8th November 2022

I wanted to voice my objection in the strongest possible terms to the proposal to create a cycle lane by the removal of residential parking for a ½ mile stretch between on the South Circular Road (SCR) between Fennessy's and Alphonsis Street.

Figure 3 An Post Parcel Delivery. No provision in plan for this.

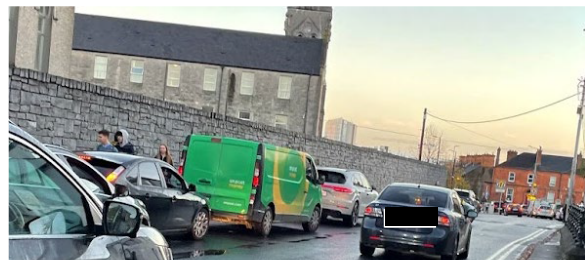
The greater issue will be access. The plan generates a 750 meter stretch of the road where cars cannot legally stop even for deliveries. Any car pulling in has to stop on the carriageway or pull onto the cycle path. This makes the houses on this stretch of road inaccessible for routine deliveries (e.g. parcel delivery, groceries, oil / fuel), there is no provision for how tradesmen could access to maintain the buildings in the area, many of which are listed and requiring constant upkeep. Families with smaller children have to be dropped and collected. This is activity that makes an area habitable, this provision would be removed. The street has a large proportion of elderly residents, they require access and care from medical professionals / home help who will need to be able to park close by.

My own kids are very active in local sports clubs, scouts etc. We carpool regularly. These routine drops and collections need a car to be

able to stop briefly close to our door. The current proposal means a car cannot stop on the SCR for a ¼ mile of my front door in either direction. This is a ridiculous situation.

Figure 4 School Bus Parking on SCR for Laurel Hill (2 schools) & St. Clements

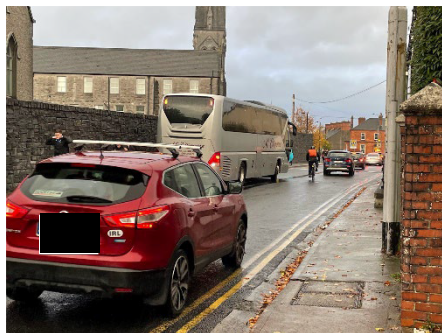
The reports prepared on the route make poor reference to access issues to the Schools, Scoil Mhathair De, Laurel Hill (both schools), St. Clements as well as the nearby Project and Model Schools. Scoil Carmel has been used on a temporary basis as a school and may return to use as a School. Mary I is also on the route. The road is particularly busy at school drop off and collection. No reference is made to where this traffic will go and how kids will be collected or be dropped off.

Busses pick up and drop off school groups from the SCR at the Redemptorist church directly for school outings. This avoids them having to take a the sharp left into the Laurel Hill or St. Clements schools. I fail to see how this is dealt with within the new road layout.
